# UNITED STATES PATENT AND TRADEMARK OFFICE

APPLICATION NO.	FILING DATE	FIRST NAMED INVENTOR	ATTORNEY DOCKET NO.	CONFIRMATION NO.
10/821,911	04/12/2004	Houng Joong Kim	A8319.0018/P018-A	2450

<b>Office Action Summary</b>	<b>Application No.</b> 10/821,911	<b>Applicant(s)</b> KIM ET AL.	
	<b>Examiner</b> Yahveh Comas	<b>Art Unit</b> 2834

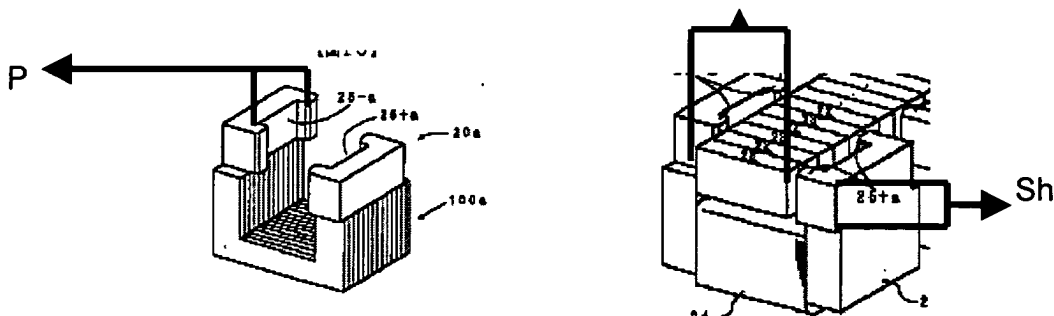
Regarding claim 13, applicant doesn't disclose a first member including a first magnetic pole and second magnetic pole each of said first and second magnetic poles comprising a plurality of magnetic pole teeth. The first member includes an upper or first magnetic pole and a second or lower magnetic pole, as show in fig 2a, but said

magnetic pole doesn't provide a plurality of teeth as claimed, therefore the specifications doesn't provide a full, clear and concise description of said feature.

Regarding claim 15, 18 and 21 specifications doesn't provide a full, clear and concise description of the height of the step portion being bigger than a gap between the magnetic pole teeth constituting the opposed portion. Therefore no patentable weight has been giving to this feature.
